Hi-Fi Products  
**Service Bulletin**

**Model:** CDP-H3600

**No. 324**

**Subject:** Disc Drawer Will Not Open And/Or Close.

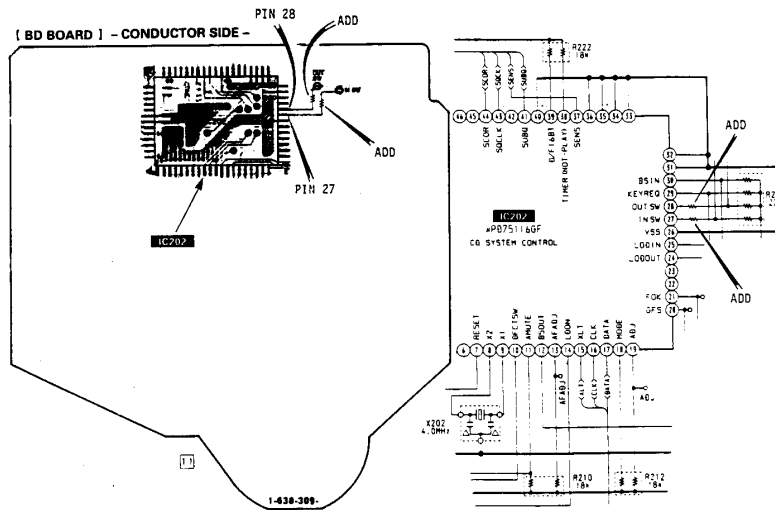
The disc drawer does not open and/or close when the Open/Close button is pressed.

After making sure that the problem is not caused by something else, replace CD system control IC-202. To prevent the problem from reappearing, add 1K resistors in series with the IN SWITCH and OUT SWITCH inputs of IC-202, pins 27 and 28. These pins must be lifted off the surface of the board.
